Hanoi, 6th March 2020

In behalf of VinFast I would like to submit our feedback regarding the different test procedures proposed in **Docket No NHTSA-2019-0102** for the assessment of ADAS. In VinFast we consider safety as a priority and we will be glad to collaborate with NHTSA in the development of safer roads for US citizens.

Lateral accelerations for turn left maneuvers at 25 km/h and 30 km/h (MUSE):

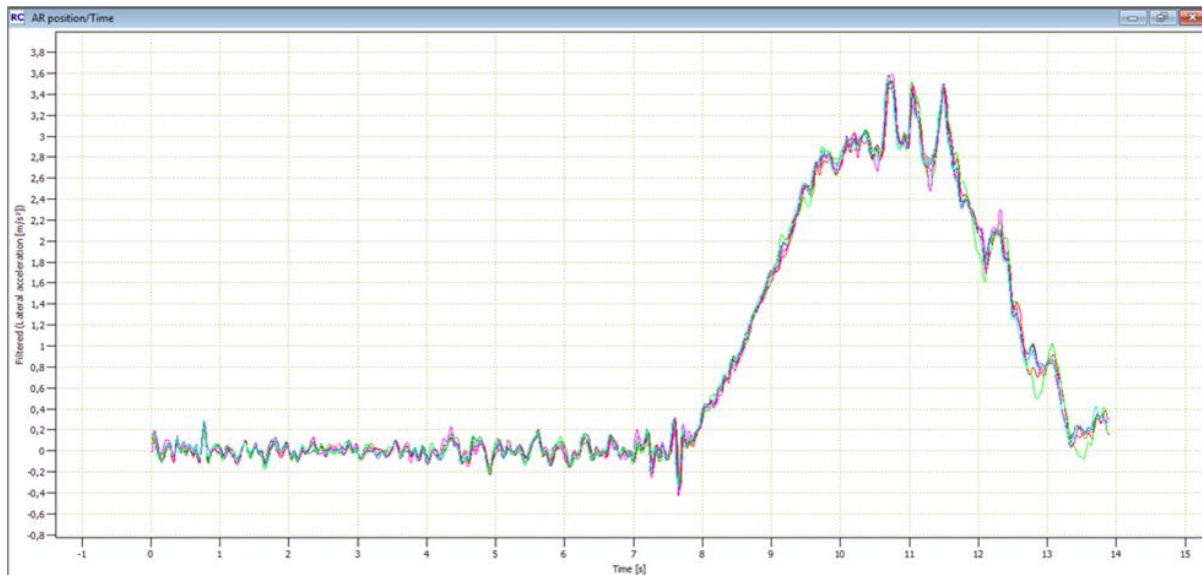
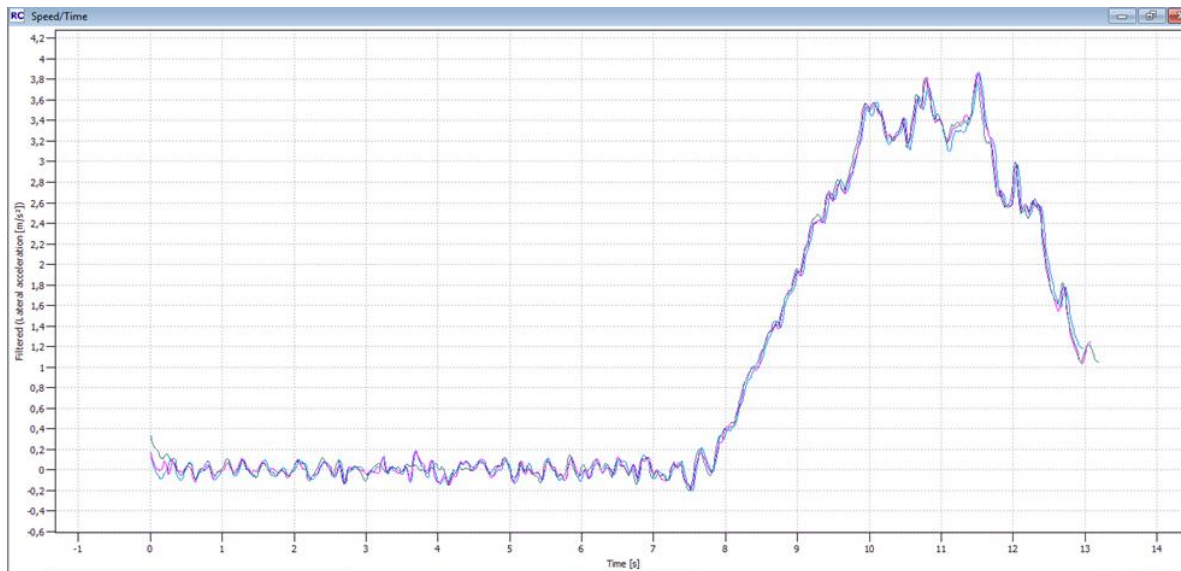
The speeds proposed for LTAP-OD scenarios are not realistic for the intersection defined in the same document.

In [MUSE](#) it was studied how the different trajectories at different speeds fitted in the intersection layout proposed by Euro NCAP (quite similar to the one proposed by NHTSA) and it was concluded that 25 km/h will be the limit of a realistic turn to left trajectory for this intersection. In NHTSA test procedure there are scenarios in which the vehicle is going from 0 to 42 kmh.

Lateral accelerations over 3.5 m/s^2 are not representative of a realistic way of turning in this kind of intersection.

We also consider that trajectories with clothoids as the ones developed in Intersection 2020 project and used in Euro NCAP CCftap scenario should be used.

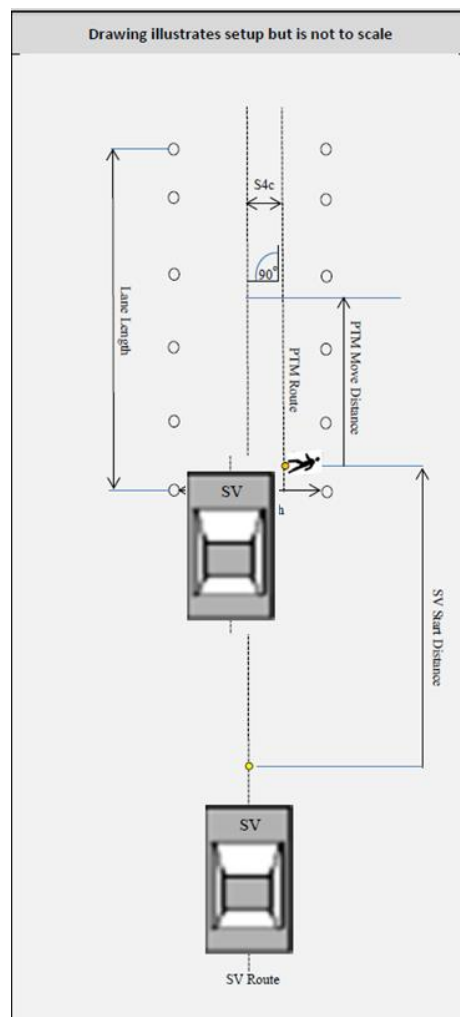
We consider that the lateral tolerances for the lateral deviation from path for both, vehicle and pedestrian, should be much smaller or more clearly defined than the ones proposed in the current version (paragraph 9.2.5.1):

For this scenario, with a low overlap, small lateral deviations in the paths could suppose a not activation of the system. Taking into account the current tolerances we could even find the situation in which the pedestrian is not even in the path of the SV. That will suppose an important dispersion in the results.
